This is in regards to the DA Application for Material Change of Use - Application Reference # A0070071997 - Lots 19 & 20 on RP 33675 - 112-112A Racecourse Road, Ascot Qld 4007.

RE: Submission in accordance with the Development Assessment Rules in relation to Development
Application for a Material Change of Use for Multiple Dwelling at 112 Racecourse Road, Ascot

Council Reference: A007001997

Figure 3: Extract of Section 1, Drawing Number DA.301 Revision 2 (A007001997), (Source: 111.company, 2026) with annotations applied showing height of lift core and setback from edge of roof

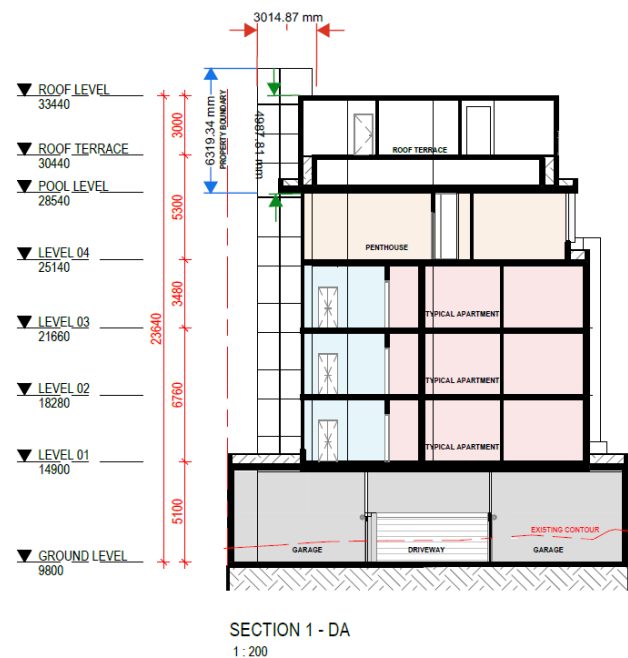
The Applicant seeks to rely on an alternative solution to **A01** of the neighbourhood plan by proposing a development that is effectively six (6) storeys in height. While the Applicant's planning reports and responses to Council's Information Request characterise the proposal as a five-storey development with a compliant rooftop garden, a detailed assessment (Appendix A) against the City Plan definition of a rooftop garden¹ demonstrates that this is inaccurate.

- The lift core is positioned adjacent to the roof edge and is therefore incapable of satisfying the applicable height controls where located within 3 metres of the rooftop's outermost projection (**Figure 3**); and
- The rooftop incorporates private open space, rather than being solely communal in nature (**Figure 4**).

The practical consequence of these non-compliances is that the development is significantly larger than represented by the Applicant. The additional storey materially increases the perceived scale of the building and further exacerbates impacts on adjoining residents. When combined with the limited setbacks proposed, the result is a development that appears excessively bulky and imposing on both

Figure 4: Extract of Roof Terrace Plan, Drawing Number DA.105 Revision 3 (A007001997), (Source: 111.company, 2026)

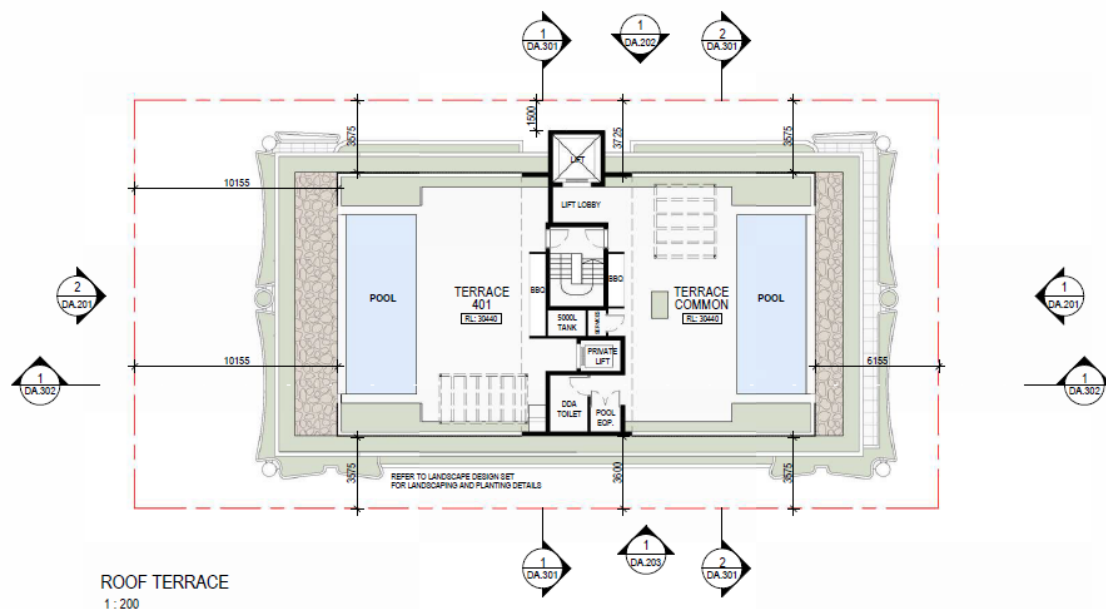
b. includes communal open space and does not include private open space;	Does not comply The proposed rooftop garden includes private open space for Terrace 401 (refer to Figure 4). Therefore, the roof top <u>does not comply</u> with the definition and constitutes the sixth storey of the proposal.

Figure 5: Extract of approved second level floor plans (A005308383) at 118 Racecourse Road, Ascot, impacted habitable rooms shown in red (Source: Loucas Zahos Architects, 2020)

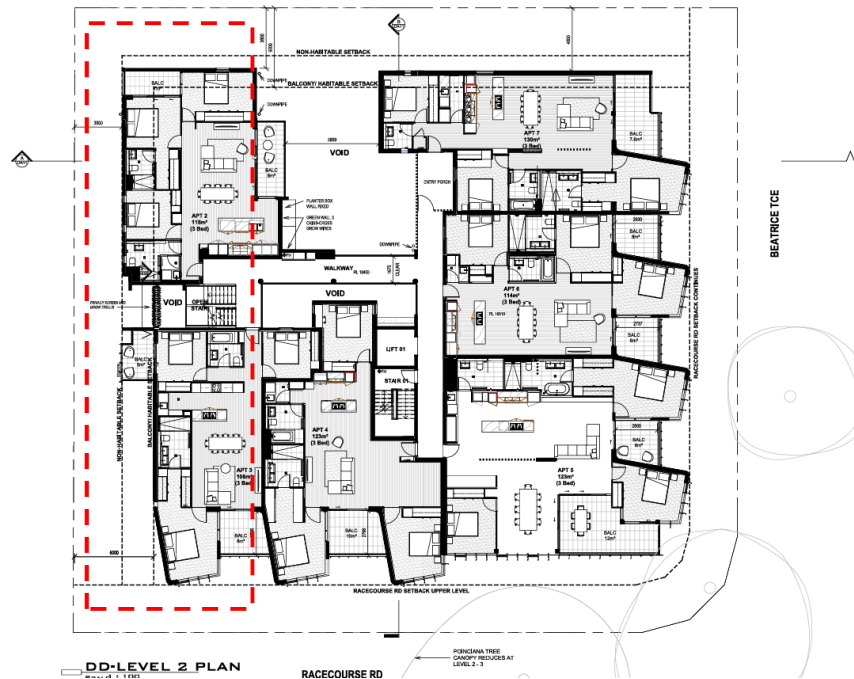
- The proposed setbacks create unacceptable amenity impacts for neighbouring residents, including residents
- The development will directly overlook multiple habitable rooms and private open space areas within our building, resulting in a significant loss of privacy for existing residents (Figure 5);
- The proposed separation distances are insufficient to maintain reasonable access to natural sunlight and ventilation, particularly given the building's height and continuous northern elevation; and
- The proposal results in a level of visual intrusion that is far greater than that reasonably anticipated by the planning framework.

The extent of the privacy impacts is demonstrated by the approved floor plans for which identify numerous habitable rooms directly exposed to overlooking from the proposed development (**Figure 5**).

Given the severity of these impacts, we respectfully submit that the proposal requires substantial design review and refinement. In particular, Council should require increased side setbacks to better reflect the scale of the proposed development and to achieve a more equitable relationship with adjoining residential buildings.

At a minimum, we request that the side setbacks be increased to 3 metres to the wall. Such an outcome would be more consistent with contemporary development approvals in the locality, including the approved development at 128 Racecourse Road, and would provide a more appropriate balance between redevelopment potential and the protection of residential amenity. A 3-metre setback would materially improve privacy outcomes, reduce visual bulk, enhance access to sunlight and ventilation, and deliver a more respectful interface with neighbouring properties.

Figure 6: Submitted Shadow Diagrams as part of RFI Response (Source: 111.company, 2026)

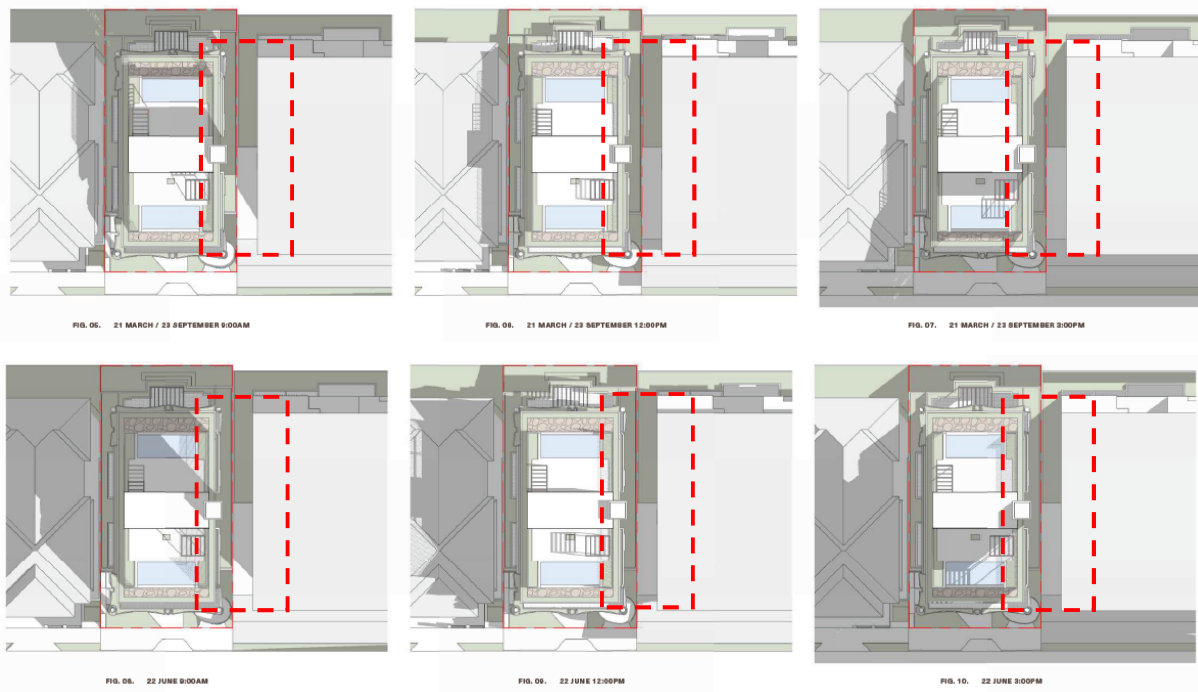
The adverse impacts on sunlight access and ventilation are further evidenced by the Applicant's own shadow diagrams. Those diagrams illustrate extensive overshadowing of adjoining properties and confirm that many of the habitable rooms identified in **Figure 5** receive little to no direct sunlight for significant periods of the year. On both the March and September equinoxes, as well as the winter solstice, substantial portions of the adjoining residential development remain overshadowed throughout the day. Even during the summer solstice, sunlight access is noticeably limited when compared with the existing situation (**Figure 6**).

The shadow impacts are not confined to Silk. Residents of 110 Racecourse Road will also be adversely affected by the proposal, particularly those dwelling units with a northern aspect that currently benefit from access to natural light. The cumulative overshadowing generated by a six-storey building with such limited setbacks is inconsistent with the amenity outcomes anticipated by the planning scheme.

Figure 9: Submitted west elevation and shadow diagrams as part of RFI Response (Source: 111.company, 2026)

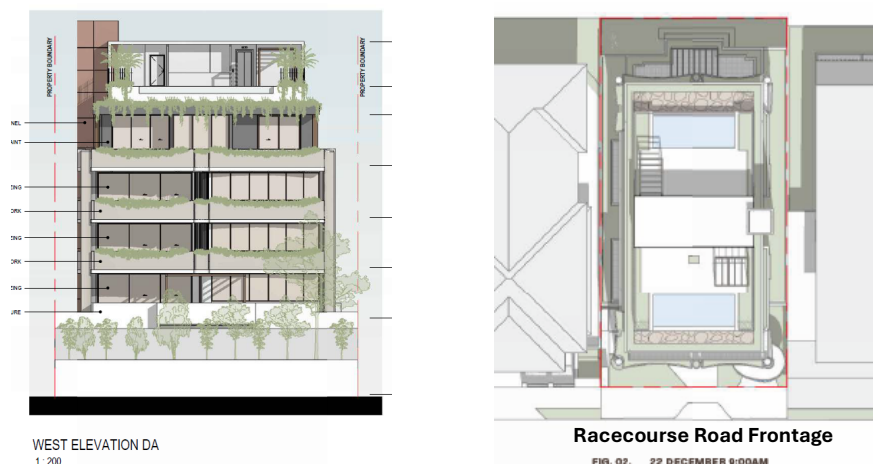
Although the proposed rear setbacks generally align with the numerical expectations of the City Plan, the overall impact of the development cannot be assessed on setbacks alone. The proposal exceeds the neighbourhood plan's anticipated height outcome by two additional storeys, substantially increasing opportunities for overlooking and creating a level of visual dominance that is not anticipated by either the planning framework or the local community (**Figure 9**).

Furthermore, the information submitted by the Applicant does not adequately demonstrate the full extent of impacts on these adjoining dwellings. The shadow diagrams accompanying the application focus primarily on the properties located to the north and south of the site and do not provide a comprehensive assessment of effects on the low-set residential properties situated along the western boundary. As a

result, Council and the community have not been provided with sufficient information to fully understand the consequences of the proposal on neighbouring character homes (**Figure 9**).
